PROJECT NAME: MANCHESTER-RUTLAND TOWN  
 PROJECT NUMBER: NH SURF(50)  
 FILE NAME: pl4v200.dgn PLOT DATE: 2/9/2016  
 PROJECT LEADER: M. FOWLER DRAWN BY: B. KIPP  
 DESIGNED BY: B. KIPP CHECKED BY: M. FOWLER  
 TRAFFIC SIGNAL SYSTEM SHEET 7 SHEET 91 OF 105

TH-5  
 COLD RIVER ROAD  
 MM 1.137 - RUTLAND TOWN  
**NOT TO SCALE**

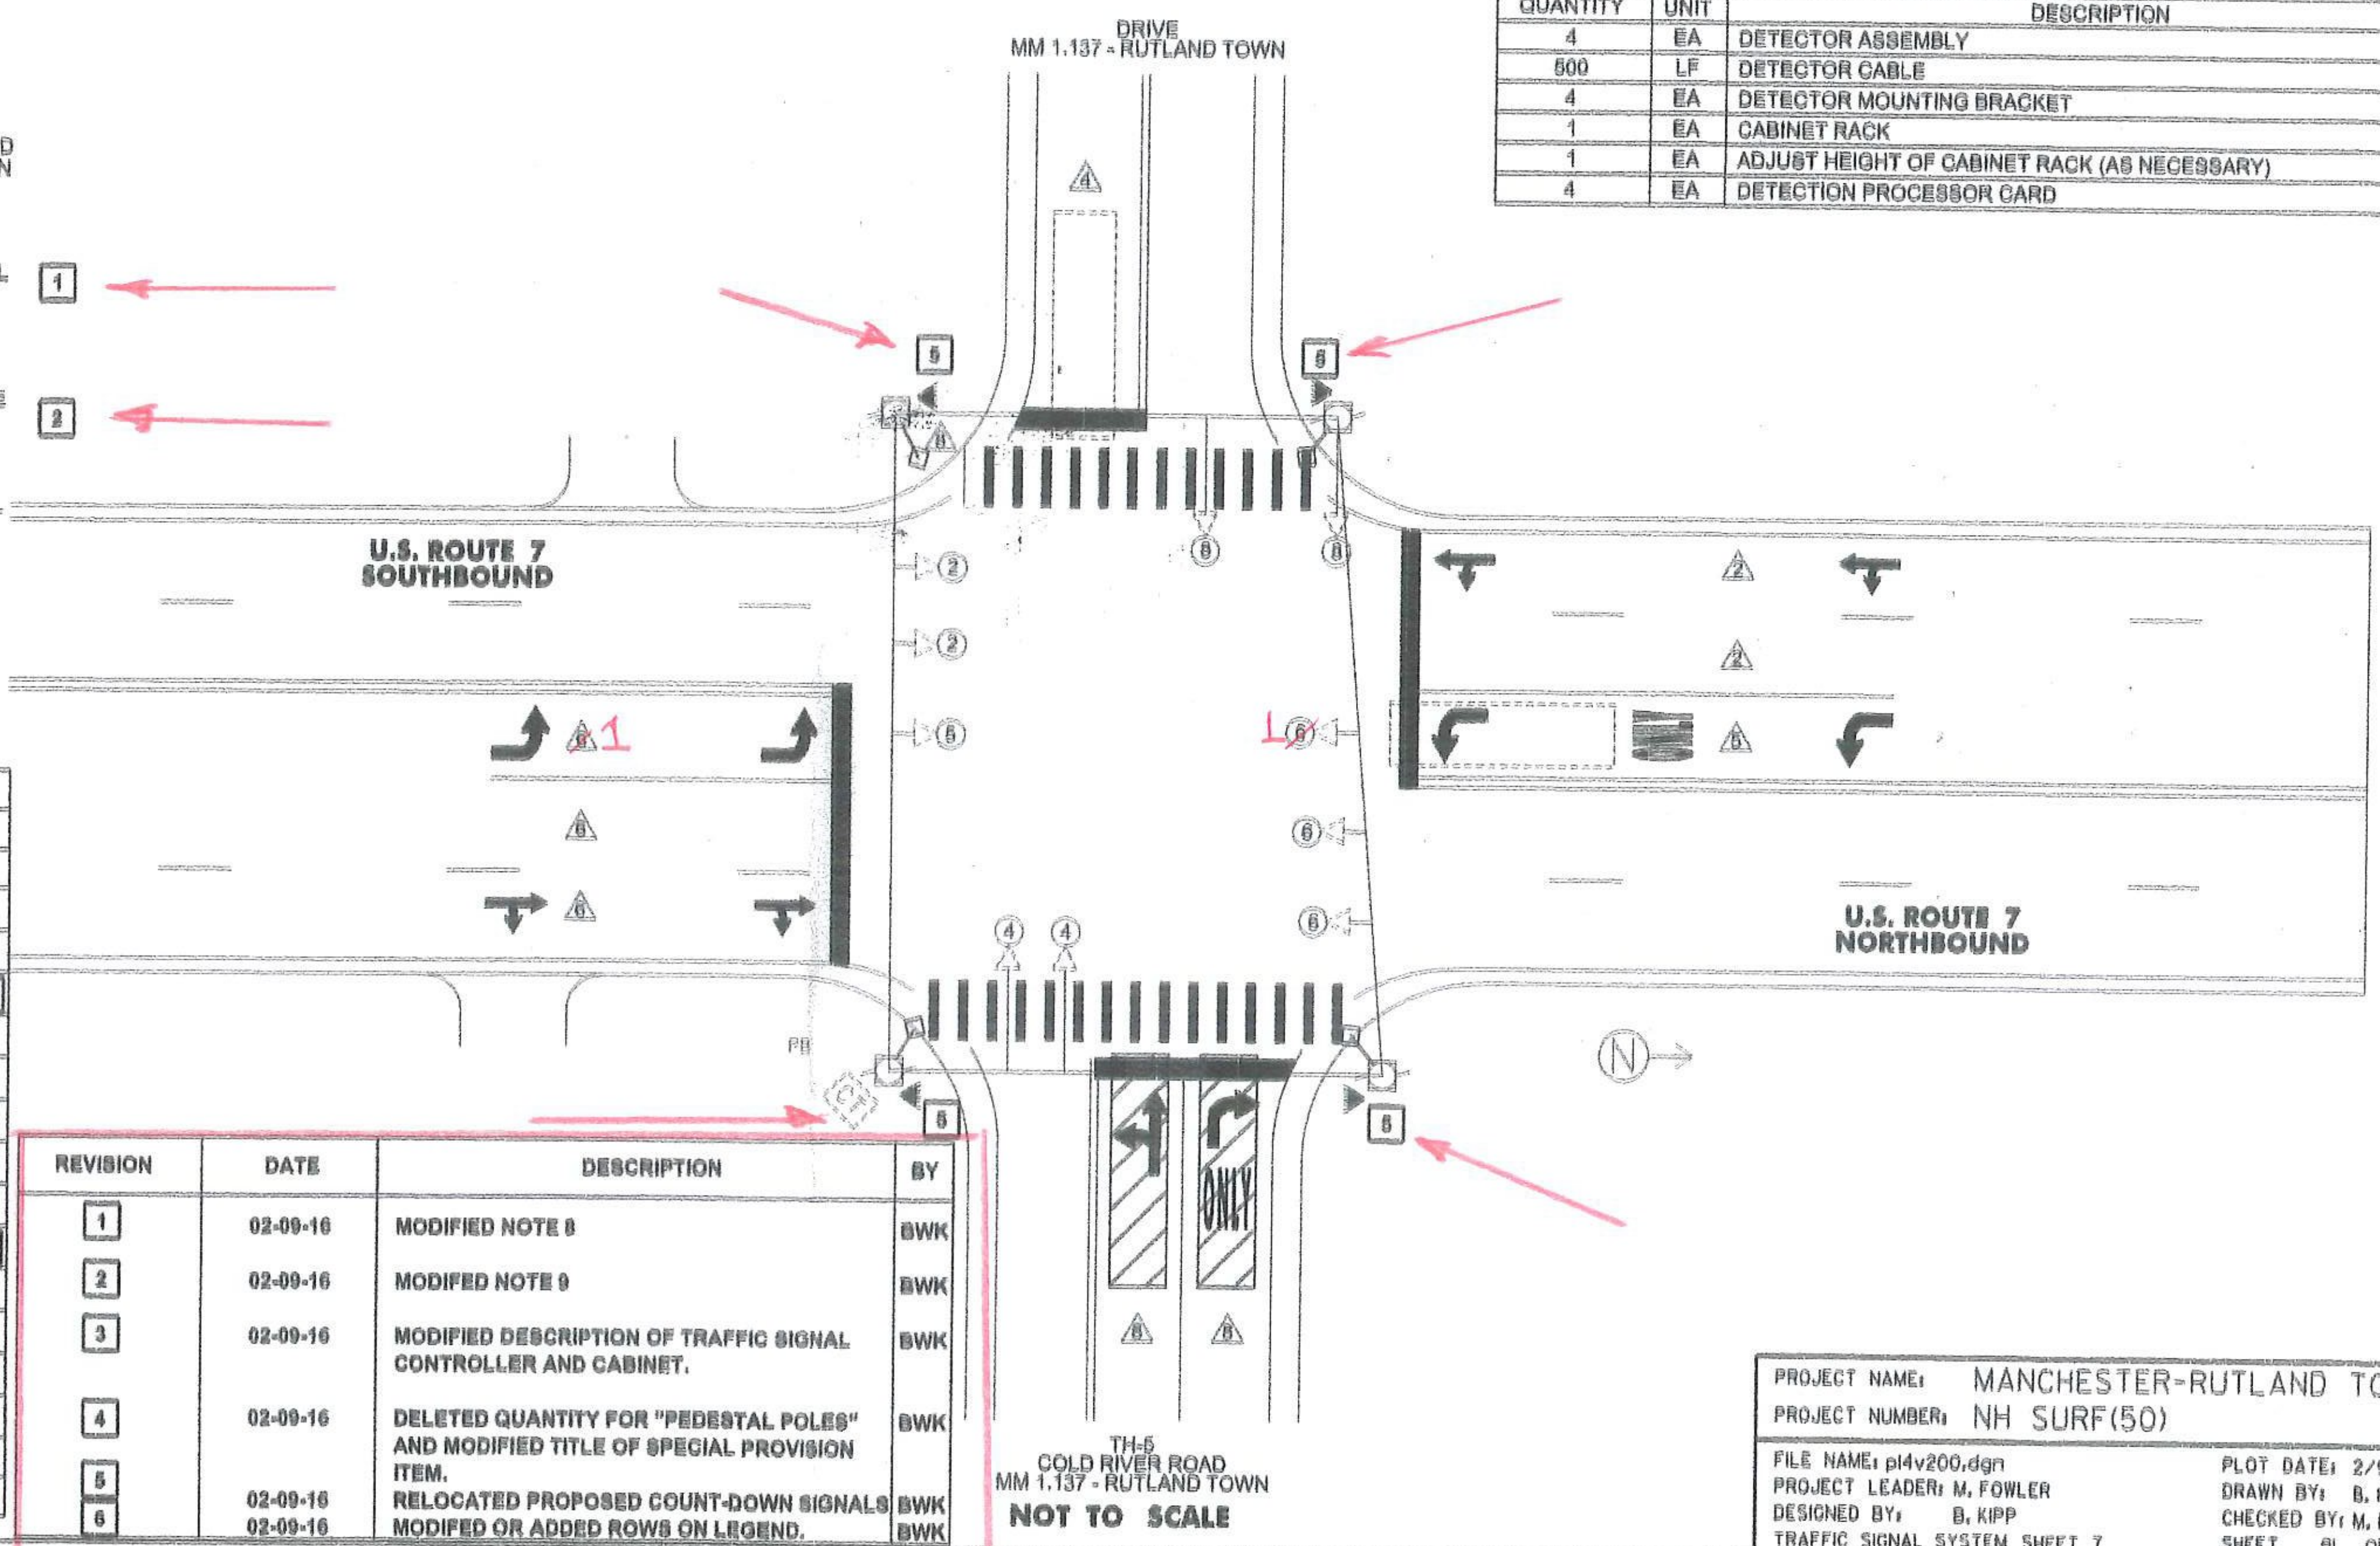
REVISION	DATE	DESCRIPTION	BY
1	02-09-16	MODIFIED NOTE 8	BWK
2	02-09-16	MODIFIED NOTE 9	BWK
3	02-09-16	MODIFIED DESCRIPTION OF TRAFFIC SIGNAL CONTROLLER AND CABINET.	BWK
4	02-09-16	DELETED QUANTITY FOR "PEDESTAL POLES" AND MODIFIED TITLE OF SPECIAL PROVISION ITEM.	BWK
5	02-09-16	RELOCATED PROPOSED COUNT-DOWN SIGNALS	BWK
6	02-09-16	MODIFIED OR ADDED ROWS ON LEGEND.	BWK
